RE: Southeast Landfill Financial Responsibility Cost Estimates
Permit No.: SO29-158504, Hillsborough County

- 1. FDEP Statement 1 - The Department has no objections to the proposed Phase IV piezometer as shown in Figure 6. Please provide all record drawings and initial measurements of leachate depth over the clay liner as part of this permit application. This information is necessary to verify compliance with the engineer's design for leachate management.**

Figure 1. Typical Well Construction for Proposed Monitoring Wells.

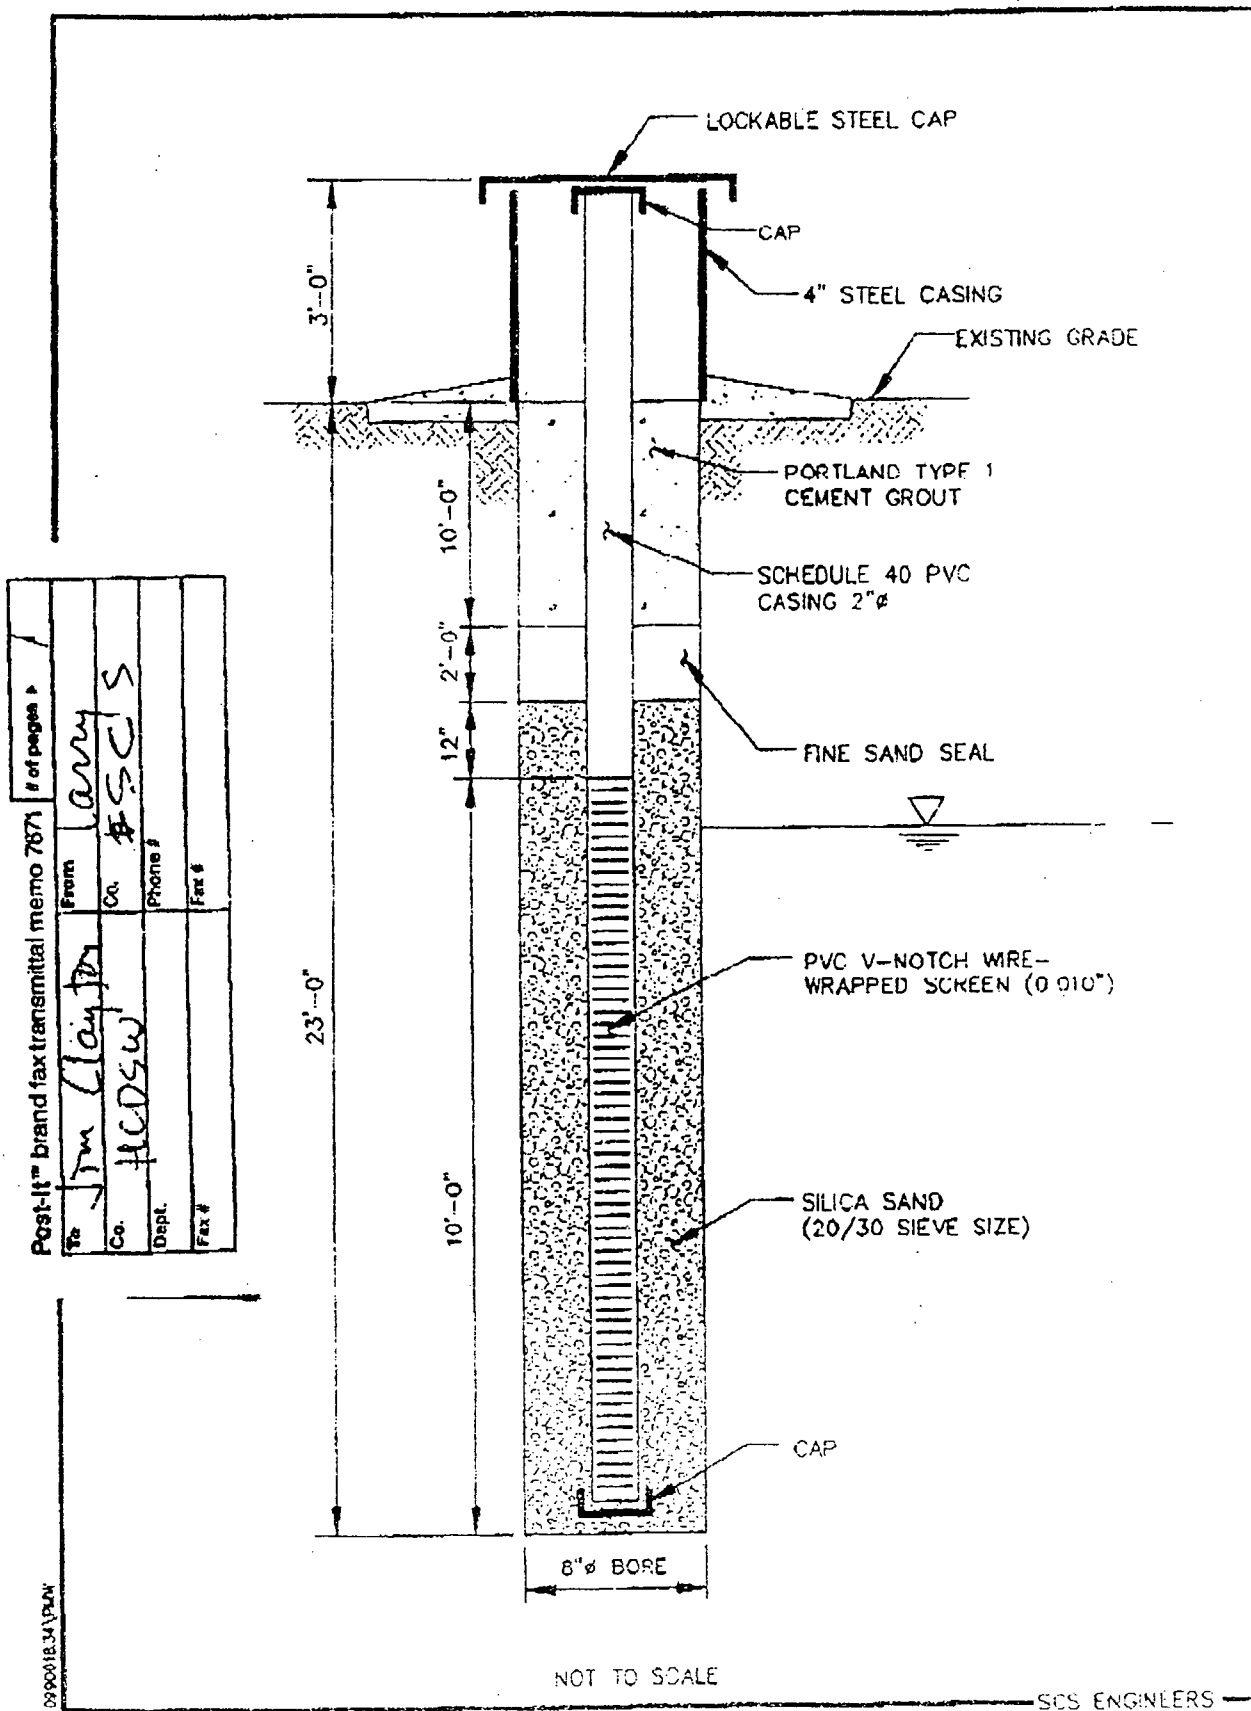
As we have previously discussed over the telephone, it is the intent of the Hillsborough County Department of Solid Waste (DSW) to replace monitor well TH-36. The monitor well has been struck and damaged during the construction of the Leachate Treatment Plant at the Southeast County Landfill.

The DSW would like for this well replacement to be included as part of the permit renewal for the Southeast County Landfill. The DSW plans to move TH-36 five feet east of its existing location. TH-36 was last sampled in November, 1994. The well will no longer be sampled due to excessive amounts of silt which is entering the well casing. Negotiations are under way with the contractor responsible for the damage to have the well relocated and replaced as soon as possible. The DSW hopes to have the matter resolved and the new well in place in the next six to twelve months. A copy of the typical well construction diagram is attached for your review.

Figure 1. Existing Limit of Sump Area.

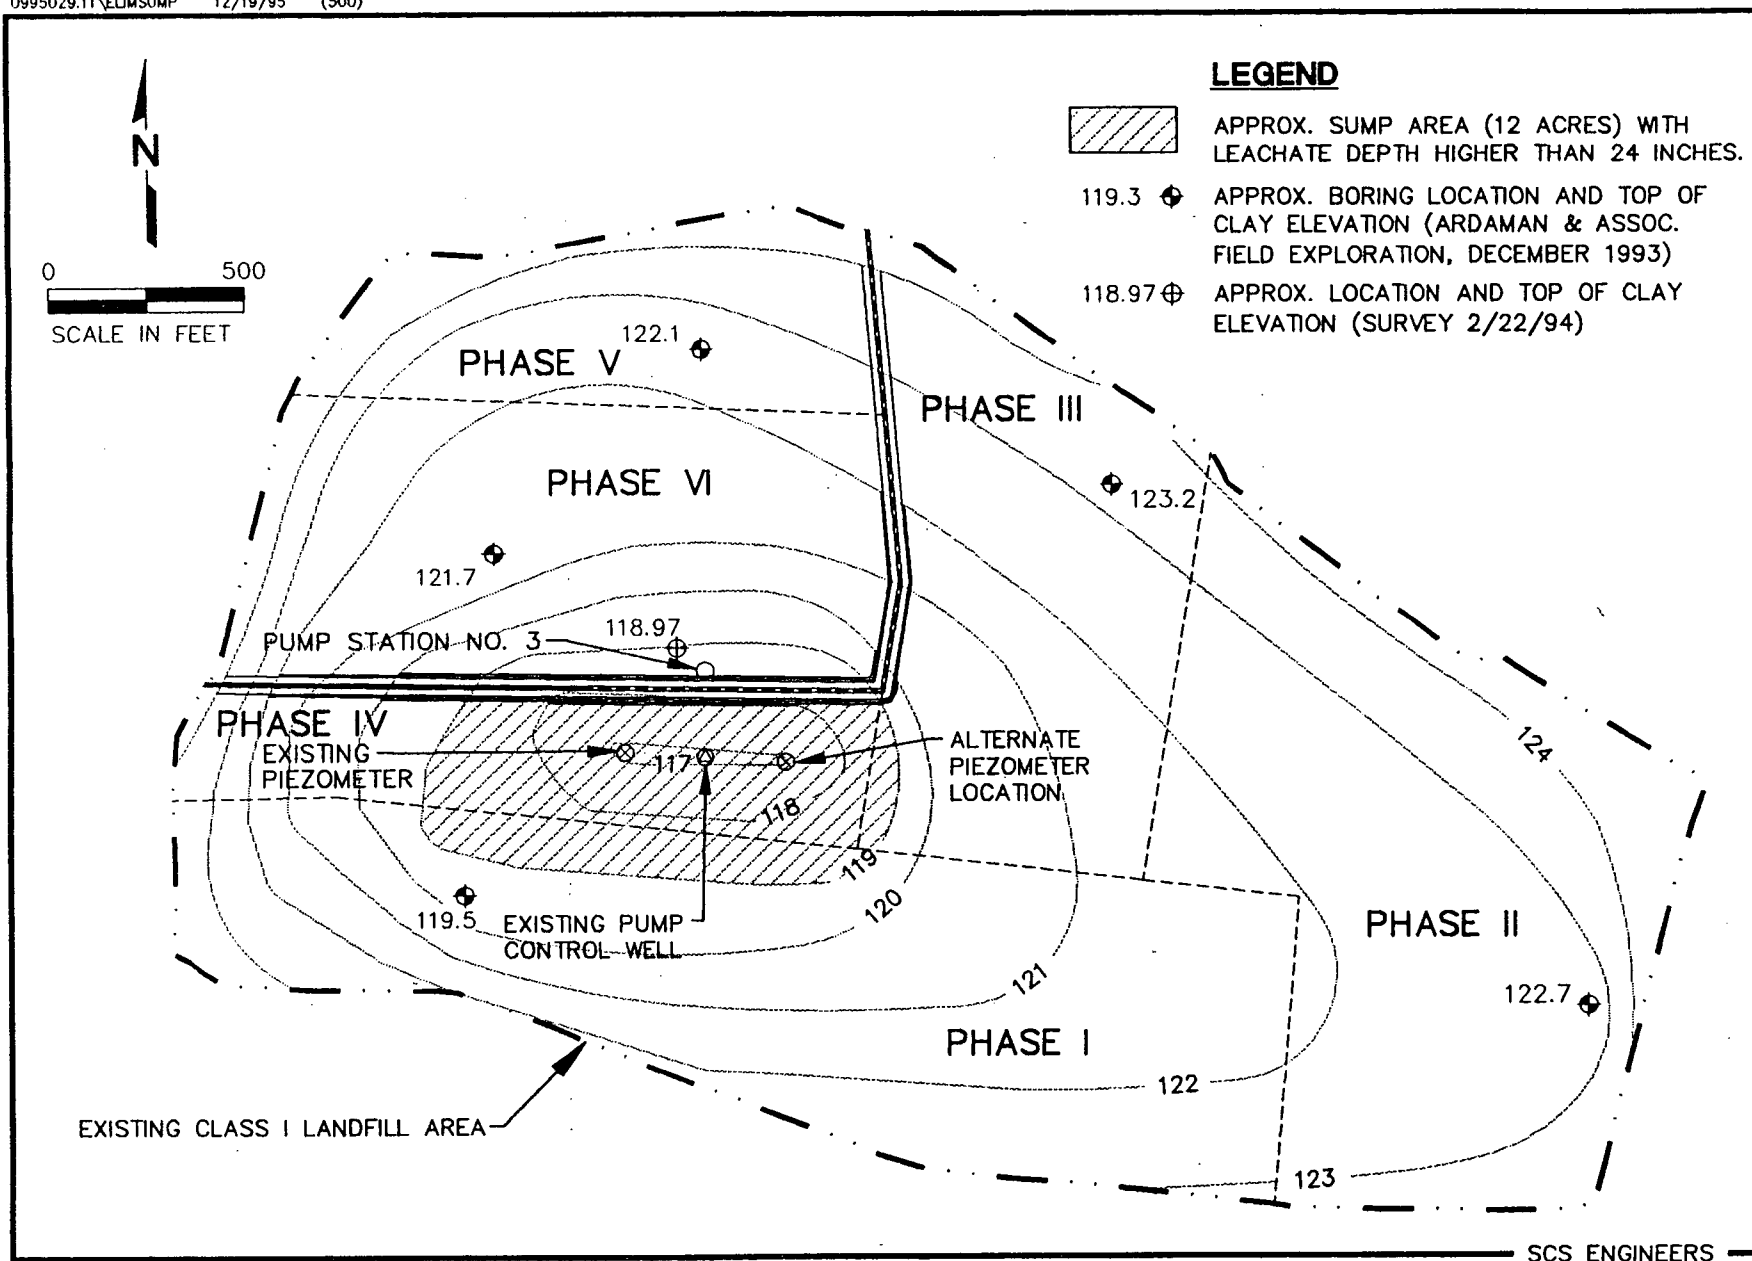
- A. On July 6, 1995, drilling for the piezometer at the alternate location as shown on Figure 1.
- B. On July 6, 1995, drilling and installation of the piezometer at the location shown on Figure 1.
- C. On August 28, 1995, construction of the suction line for TPS-5.
- D. On November 21, 1995, drilling and installation of the TPS-5 pump control well at the location shown on Figure 1.

Figure 2. Phase IV Cross Section

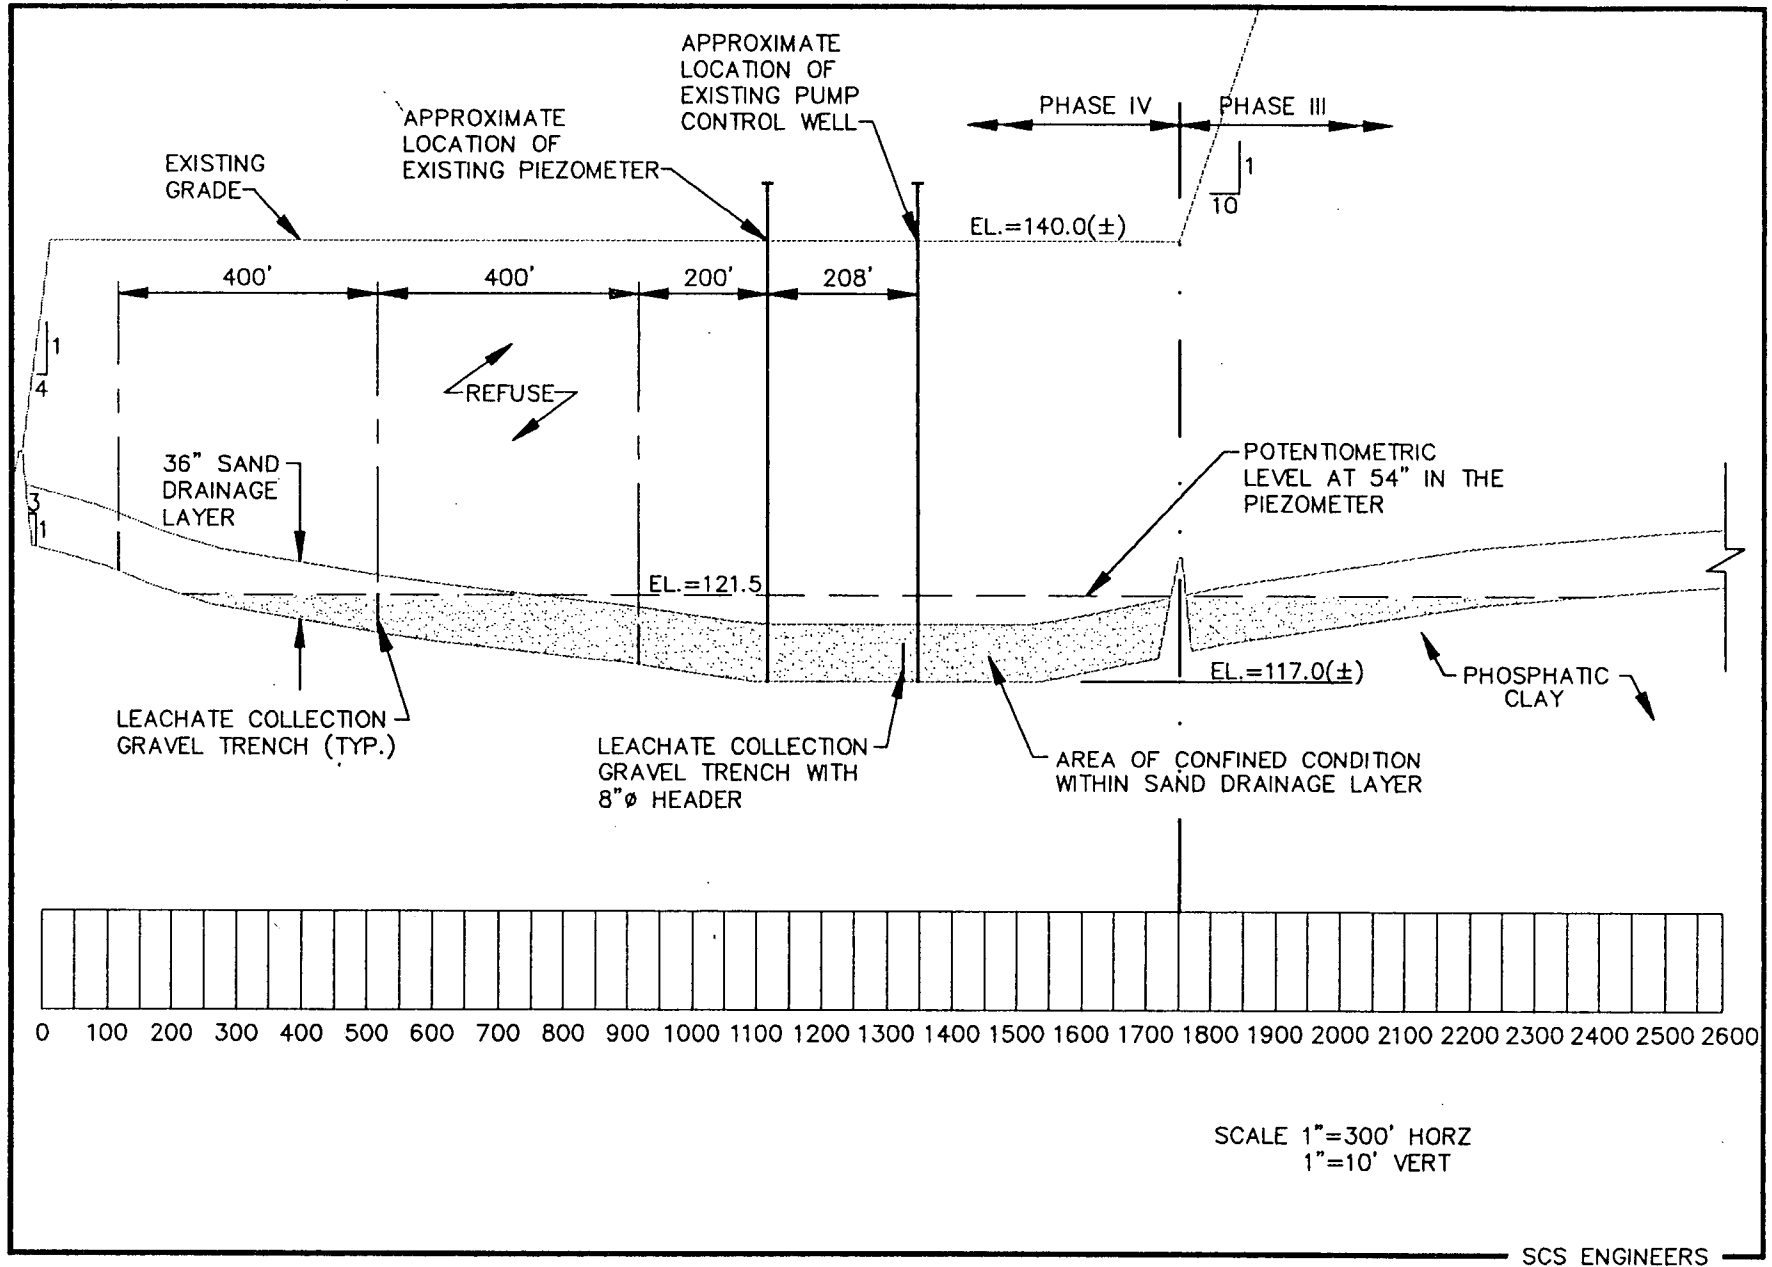
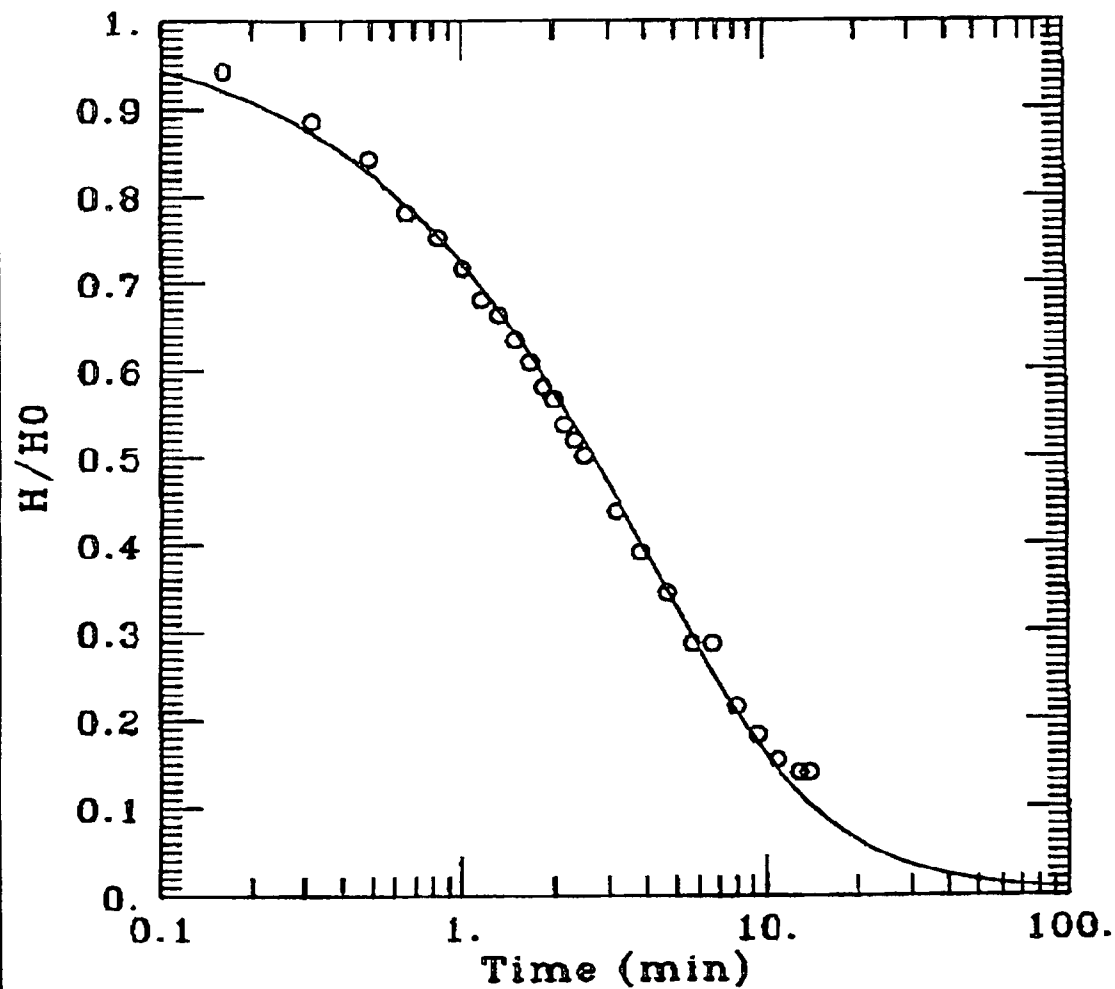
These construction activities have provided sufficient data to indicate that the leachate level observed in the piezometer is a potentiometric level (Figure 2) due to the semi-confining conditions above and below the sand drainage layer (i.e. ash and phosphatic clay

FIGURE 1

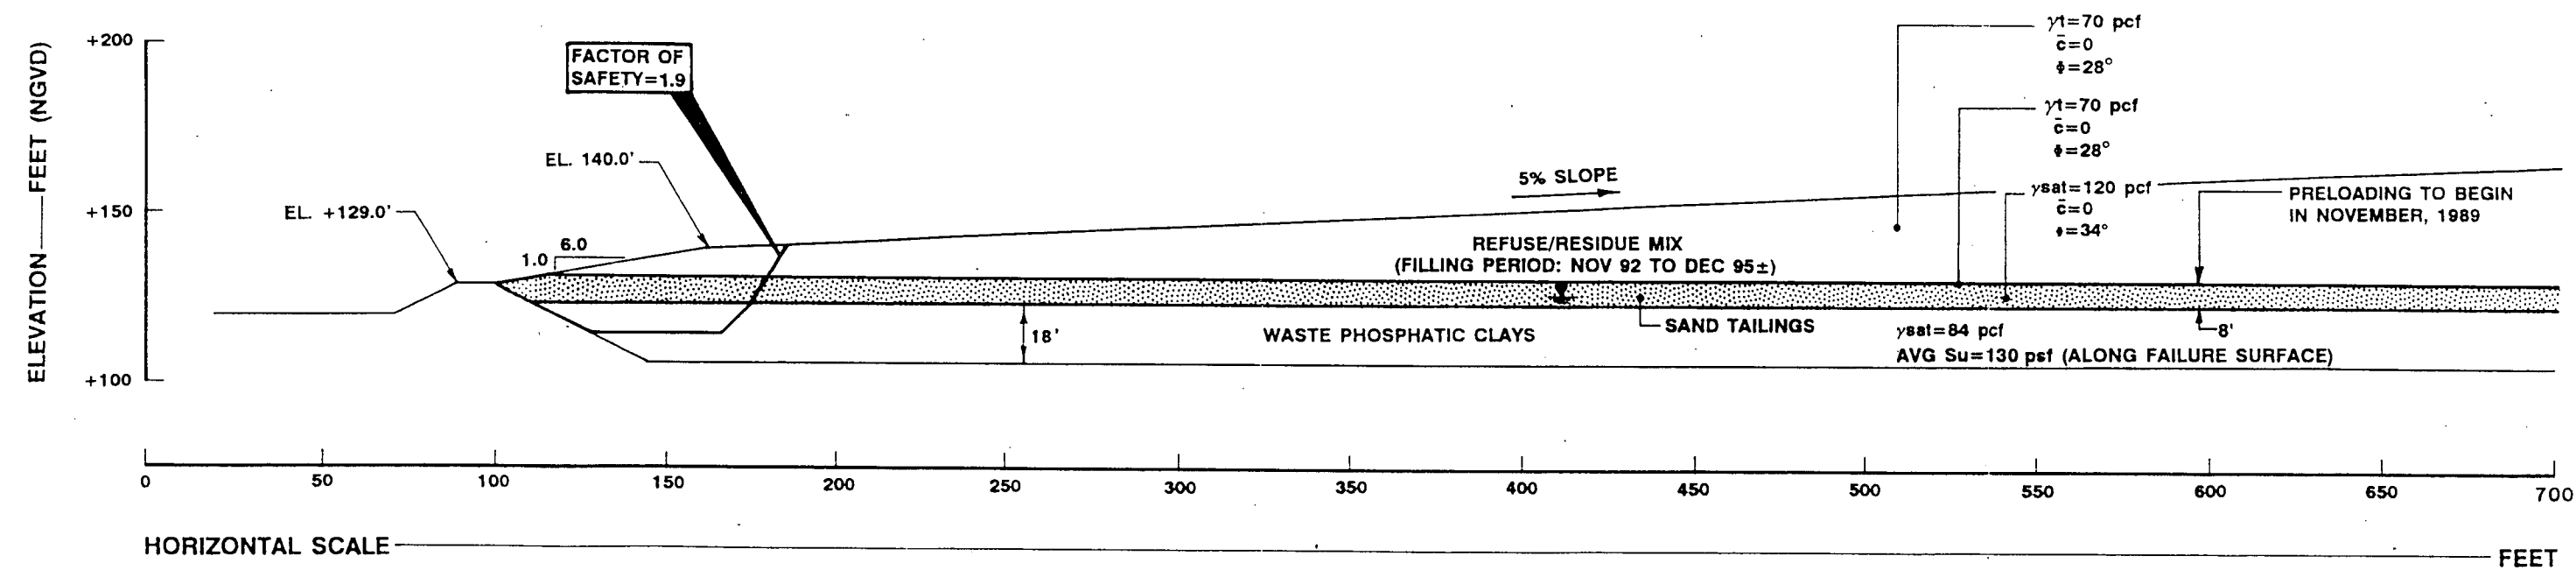
As requested by Mr. Robert Gardner of SCS Engineers, we have analyzed the effects of retaining the 8 feet of surcharge instead of the 6 feet previously requested by the county. As shown in Figure 1 and as expected, the factor of safety will increase from 1.6 to about 1.9 for the first lift of refuse/residue mixture. The additional 2 feet of surcharge, had they been placed in November, 1989, is expected to raise the undrained shear strength of the foundation clay at mid-depth from about 110 pounds per square foot (psf) to 130 psf. For the second lift of refuse/residue mix, the undrained shear strength is expected to increase from 180 to 220 psf with a resulting increase in the safety factor from 1.2 to 1.4 for the landfill design section (Figure 2). In our opinion, this factor of safety is not adequate, or at best marginal, for the proposed construction. However, if a seven-year consolidation period is provided as originally planned rather than the three-year period currently projected, the foundation clay will be close to 100 percent consolidated and the average undrained shear strength along the failure surface will be approximately 270 psf. According to our analyses, this scenario yields a factor of safety slightly greater than 1.5 and is acceptable.
